[Docket No. FAA–2023–0668; Project Identifier AD–2023–00199–R; Amendment 39–22453; AD 2023–11–07]

Airworthiness Directives; Various Helicopters

Final rule; request for comments.

Figure 1 to paragraph (g)(1)(i)— *Fundamental Effective Isotropic PSD at Outside Interface of Rotorcraft Antenna*

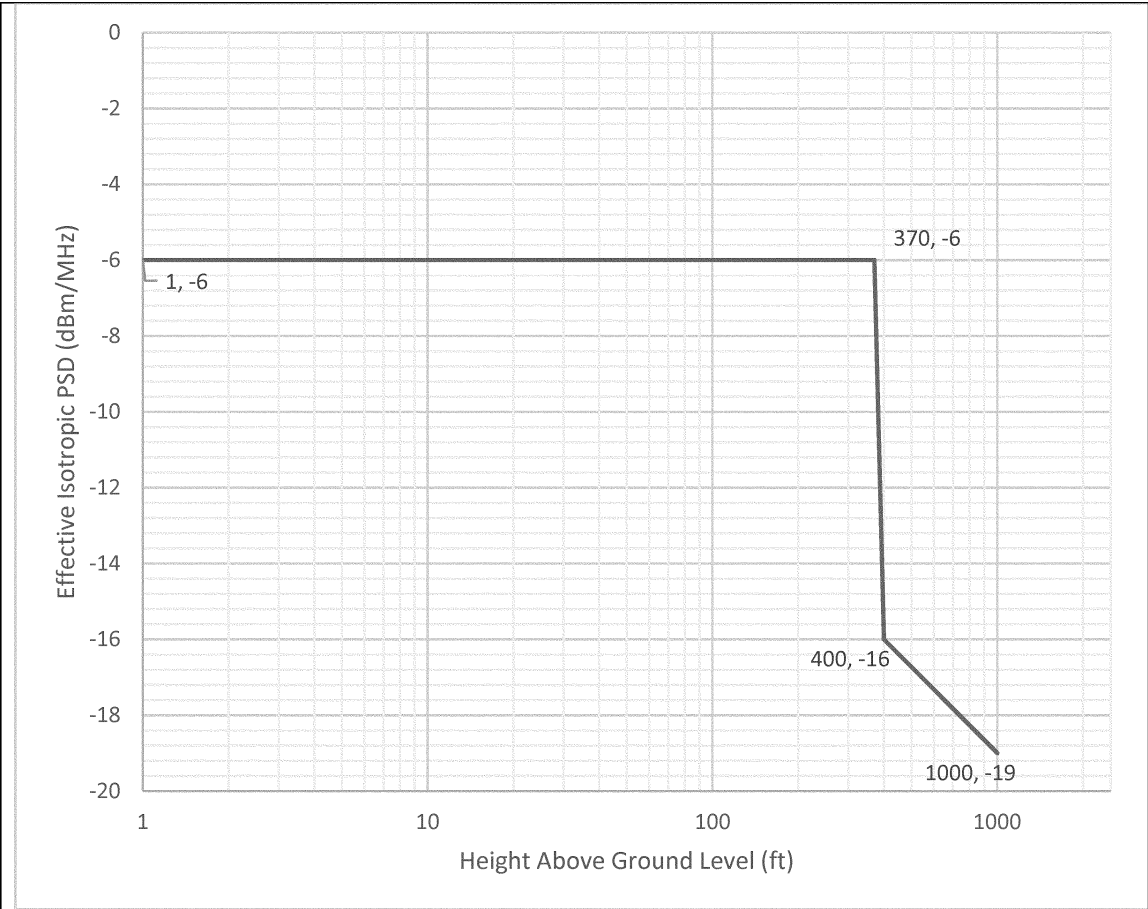
Comment summary: Thales and Sikorsky requested the FAA clarify several aspects of the PSD curve in figure 1 to paragraph (g)(1) of the proposed AD: whether no elevation mask is taken into account at and below 350 feet above ground level (AGL); at which base station emission power the PSD curve corresponds (62 dBm/MHz or 65 dBm/MHz); and whether the radio altimeter performance criteria in the curve explicitly covers any 5G emitter station up to 65dBm/MHz in the applicable 3.7–3.98 GHz band, for the foreseeable future. Sikorsky requested that the FAA revise the proposed AD to include a PSD curve that reflects the reduced EIRP levels for helicopters operating at the 188 priority airports (5G CMAs) with reduced power levels.

Comment summary: Sikorsky requested the FAA revise the PSD curve in figure 1 to paragraph (g)(1) of the proposed AD to change the height above ground at –6 dBm/MHz from 270 feet to 370 feet, and at –16 dBm/MHz from 300 feet to 400 feet. Sikorsky stated its request was based on several factors, including the minimum safe obstacle avoidance distance and the typical decision height used for radio altimeter critical operations associated with missed approach points (MAPs) during point in space (PINS) approaches. Sikorsky further stated that radio altimeters are not operationally used above 1000 feet, and therefore there is little value for any PSD restrictions above 1000 feet operationally.

FAA response: The notch in the PSD curve does not mean that no elevation mask is taken into account below 350 feet AGL. The elevation mask is taken into consideration below 350 feet AGL and is a fundamental consideration in how the PSD curve was established. The PSD curve was calibrated to cover 5G C-Band emitter stations up to 65 dBm/MHz in the applicable 3.7–3.98 GHz band.

The FAA disagrees with revising the AD to include a PSD curve for helicopters operating at airports with reduced power levels. The radio altimeter tolerant rotorcraft PSD curve was established to provide safe operation anywhere in the contiguous U.S. regardless of whether a helicopter is operating at a 5G CMA.

FAA response: The FAA assumed an emitter base station height of 350 feet based on consensus reached in rotorcraft industry group meetings. Additionally, FAA analysis of existing emitter base station height data shows that, while higher emitters do exist, they are infrequently adjacent to helipads. Second, the FAA assumed the rotorcraft was no closer than 50 feet above and 75 feet laterally from the emitter. The vertical distance was based on pilot feedback and the lateral distance was based on common lateral separation from the main rotor tip recommendations of 2 main rotor diameters from the tip of the rotor, selecting a 30 foot rotor as the smallest rotor in this class of aircraft with the antenna under the main rotor mast. An operator of an individual model rotorcraft with a larger rotor diameter may request approval of an AMOC to the AD on the basis of separation distance. Third, the FAA assumed that the emitter was active at the full rural power level of 65 dBm/MHz allowed in FCC Report and Order FCC 20–22.[\[2\]](#) The FAA then evaluated the resulting curve against data from radio altimeters and found it to be achievable with current technology using filters that have been developed. Based on data from existing emitters, if the height reduction from 370 feet to 270 feet, as requested by the commenter, were adopted, it would result in many more landing scenarios unprotected from

interference because emitters on towers at about 250 feet as opposed to the accepted assumption of 350 feet are much more common. For this reason, the FAA did not adopt this request.

The FAA has re-evaluated the need for PSD performance requirements above 1000 feet and agrees with the reasons provided by the commenter. The PSD curves specified in this AD have been changed accordingly.

Figure 2 to paragraph (g)(1)(ii): *Spurious Effective Isotropic PSD at Outside Interface of Rotorcraft Antenna*

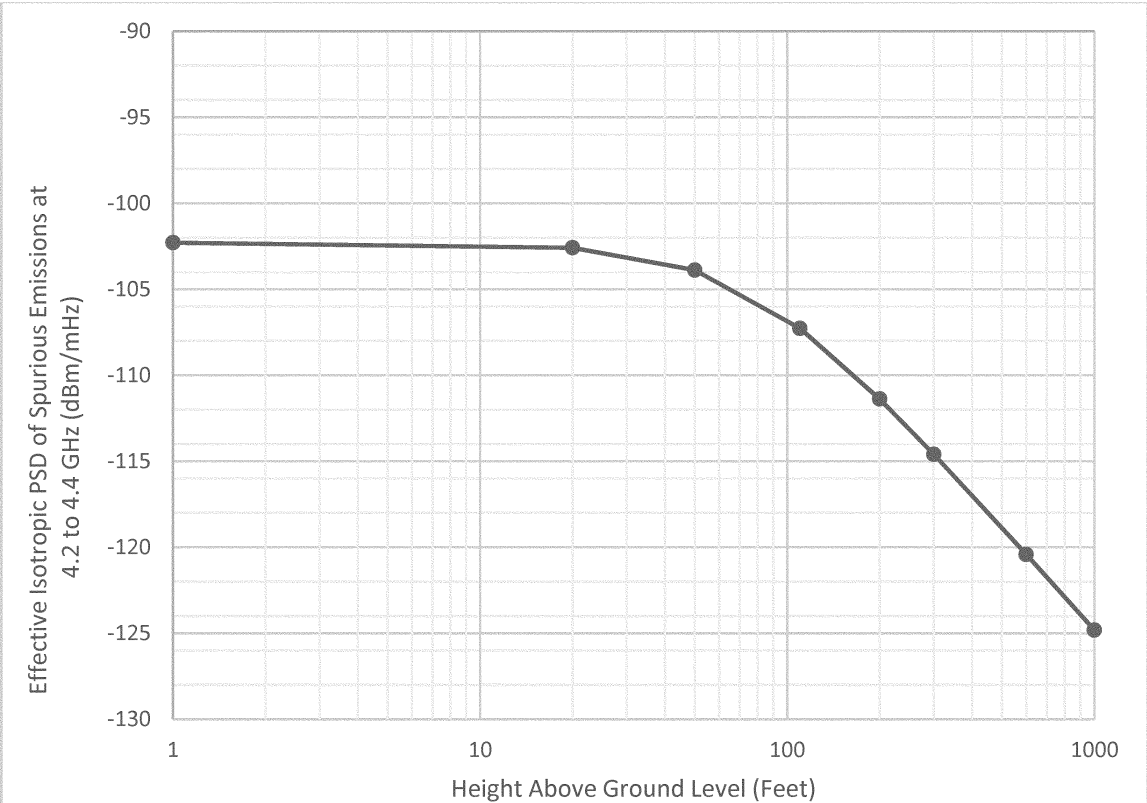
Since the FAA issued the NPRM, the FAA determined that the spurious emission level as proposed in the NPRM would not necessarily address the unsafe condition from both indoor and outdoor emitters. Additionally, commenters of the NPRM requested the FAA replace the proposed fixed aggregate spurious emission level with a spurious PSD tolerance curve.

Comment summary: HAI, Sikorsky, and Thales requested that the FAA revise the proposed AD to include the frequency range to which the PSD tolerance curve thresholds apply, a new figure indicating the spurious tolerance similar to the figure with the PSD tolerance curve, and a specification of the altitude dependence for spurious tolerance.

In this final rule, the FAA replaced the proposed fixed aggregate spurious emission level of -42 dBm/MHz (conducted) with a spurious PSD tolerance curve for 5G C-Band interference from a single base station. This form of the requirement is consistent with the transport and commuter category airplane requirement. Similarly, it does not include an aggregation factor or any base station or aircraft antenna gain factors. The spurious PSD tolerance curve is based on a different spurious emission level than what the FAA proposed in the NPRM (-30 dBm/MHz conducted for a single indoor base station instead of -48 dBm/MHz conducted for a single outdoor base station and an aggregation factor of 6 dB which yielded an effective aggregate level of -42 dBm/MHz).

FAA response: The FAA agrees and has added the frequency range to the PSD tolerance curve. Additionally, as explained previously under “Actions Since the NPRM Was Issued,” the FAA has replaced the proposed fixed emission level with a spurious PSD tolerance curve.
